# Service Bulletin

**Product Family: Gravely Pro-Turn 600 Mowers with EFI**

**Subject: Possible Reversed Wires on Warning Lights**

**Dealer Action: Inspect Warning Light Connections; Correct If Necessary**

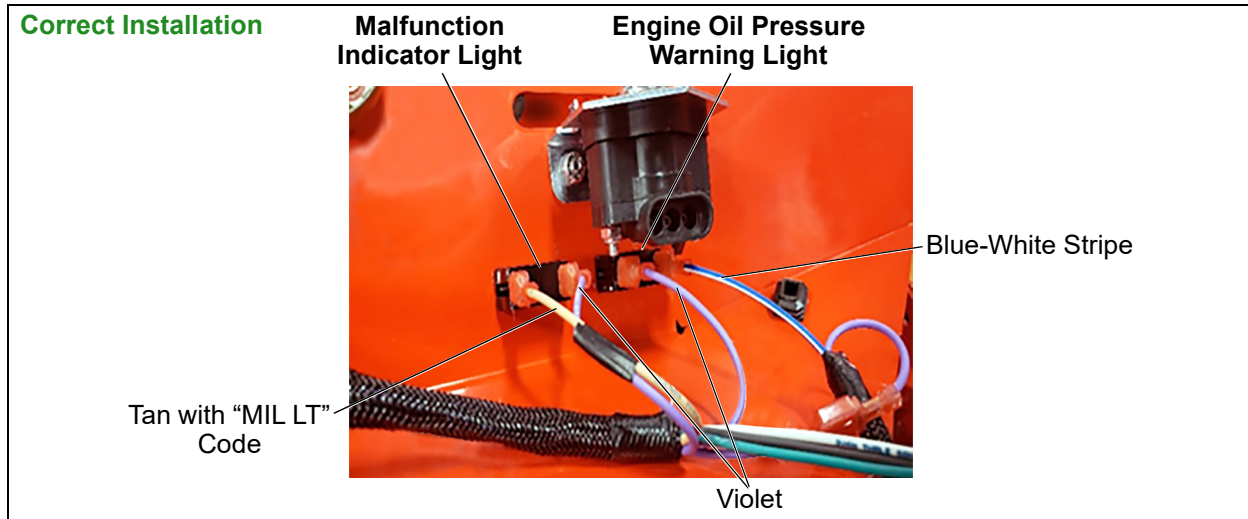
Ariens Company has learned that the wire connections to the malfunction indicator light (MIL) and the oil pressure warning light may have been reversed during installation. This condition will cause the oil warning light to glow if an engine malfunction is detected and the MIL to glow if there is low oil pressure.

Before retailing these units, dealers are to remove the tapping screws retaining the right-side control panel, carefully raise the panel and inspect the warning light connections. The correct wire-to-light connection is shown below. If the wires are correctly installed, no further action is required.

If wires are incorrectly installed, carefully disconnect the wire pairs and reconnect them to the proper light. Note that the lights do not have polarity, so the violet wires can connect to either terminal on each light.

- Violet and Blue-White Stripe Wires = Engine Oil Pressure Light
- Violet and Tan Wire Pair = Malfunction Indicator Light

Upon completion of inspection and correction if necessary, reinstall the control panel with the tapping screws removed earlier. Avoid damage! DO NOT overtighten tapping screws.

**Maximum torque = 2 N•m – 2.6 N•m (18 lb-in – 23 lb-in).**
